**Re: CI 40425 – Kempt Road Transformer - NSPI Information Requests (IRs) -
Second Set P –510/Matter No. 03715**

CI 40425 - Kempt Road Transformer (NSUARB P-510)
NSPI Responses to UARB Information Requests

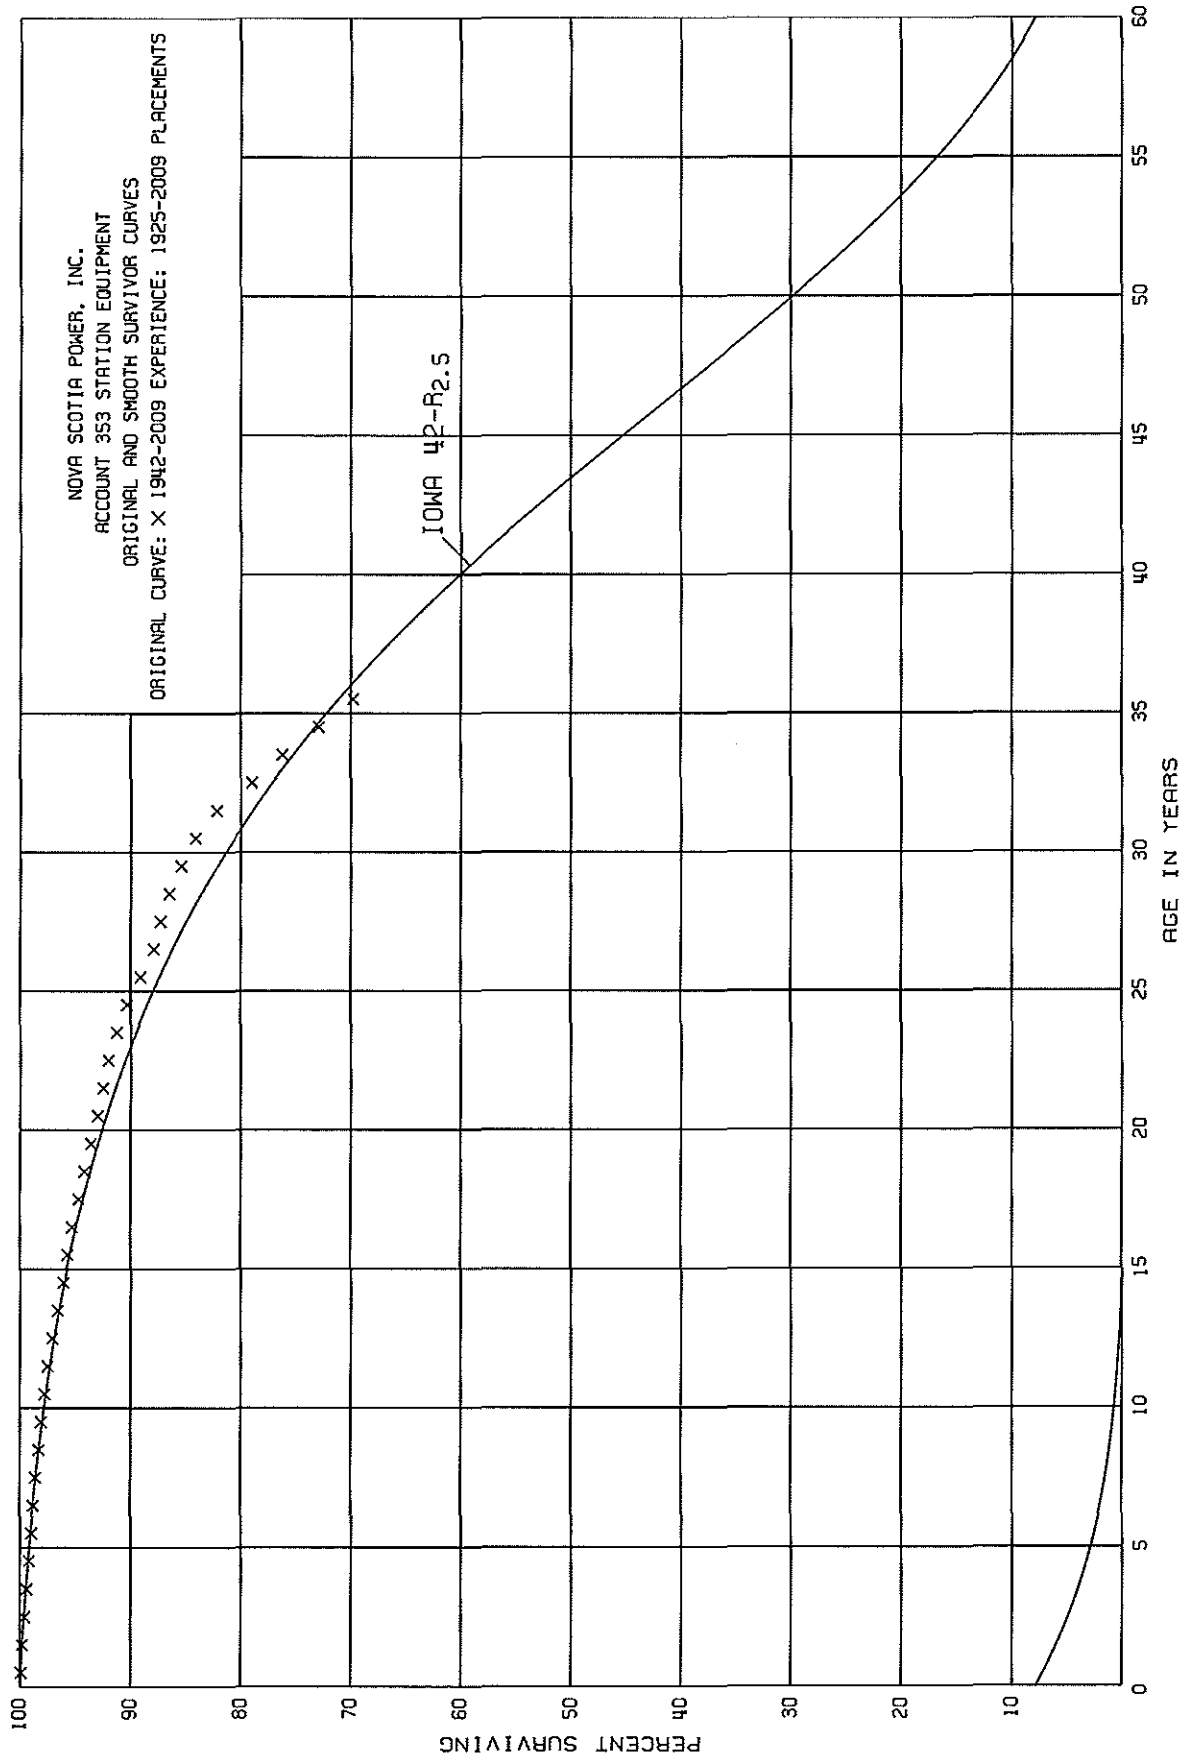
(a) It is noted that the life expectancy of transformers being used at the Kempt Road Substation is "less than 45 years". Please quantify the quoted phrase.

(b) Please provide any scientific or statistical analysis which can support "45 years" and "less than 45 years".

(b) Please refer to Attachment 1. This attachment is Appendix A, page 69 from the Iowa State Survivor Curve 2010 Depreciation Report. This information indicates the life of station equipment to be 42 years. In this case, station equipment is defined to include electrical control equipment, station service, transformers, circuit breakers and other items used in the construction and operation of a substation. The statement "less than 45 years", which is explained in part (a) is based more on an engineering judgment and the history of the units at Kempt Road than a scientific or statistical analysis.
